Access Compliance Report

Public Rights-of-Way

(Curb Ramps)

Intersection ID: 10036601	Main Street: RUSHMORE_DR	Cross Street: N/A	Location: W
ADA ID: 46BB51206A95	Ramp Type: Perp	Initial Pass/Fail: Pass	Overall Compliance: No
Codes/Mitigation Info/Possible Solution		Field Measurements/Component Compliance	
Severity Score: 15.25

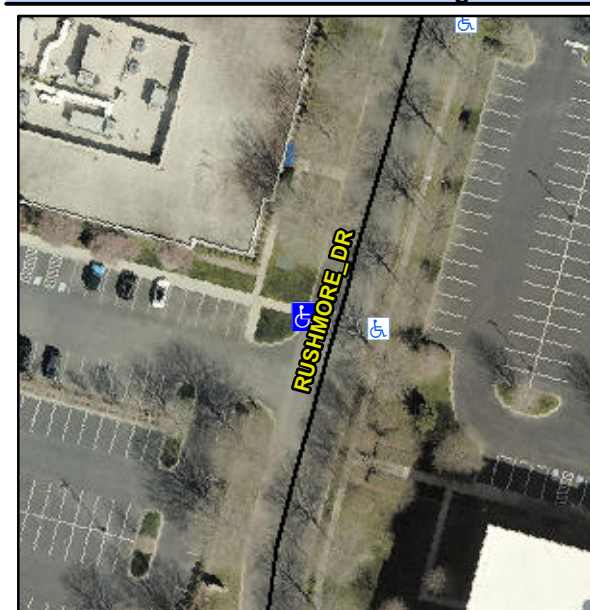
**Not Found, R304.5.3, R304.2.2-Perp,
R304.3.2-Para, R305, R304.5.4**

Compliance	Description	Data	Compliance	Description	Data
N/A	Ramp Length (in)	64.0	Yes	Ramp Slope (%)	5.2
Yes	Ramp Width (in)	60.0	No	Ramp XSlope (%)	3.3
N/A	Flare Type LT	Sloped	N/A	Flare Type RT	N/A
N/A	Flare Slope LT (%)	9.5	N/A	Flare Slope RT (%)	18.5
N/A	Flare Traversable LT?	No	N/A	Flare Traversable RT?	No
Yes	Landing Length (in)	51.0	No	DWS Provided?	No
Yes	Landing Width (in)	60.0	N/A	DWS Contrast?	No
No	Landing Slope (%)	4.2	N/A	DWS Length (in)	N/A
No	Landing X Slope (%)	2.7	N/A	DWS Full Width?	No
N/A	Landing Curb? (Y/N)	No	N/A	DWS Offset (in)	N/A
N/A	Shared Landing?	No			
Yes	Gutter Ponding?	No	No	Gutter Slope (%)	7.0
Yes	Gutter Lip Ht (in)	0.0	No	Gutter X Slope (%)	3.2
N/A	Painted X Walk1?	Yes	N/A	Painted X Walk2?	N/A
	X Walk 1 Direction	To E		X Walk 2 Direction	N/A
N/A	X Walk 1 Width (in)	88.0	N/A	X Walk 2 Width (in)	N/A
	X Walk 1 Slope (%)	4.4		X Walk 2 Slope (%)	N/A
	X Walk 1 X Slope (%)	1.8		X Walk 2 X Slope (%)	N/A

**Remove & Replace Entire Ramp.
Remove & Replace Gutter.**
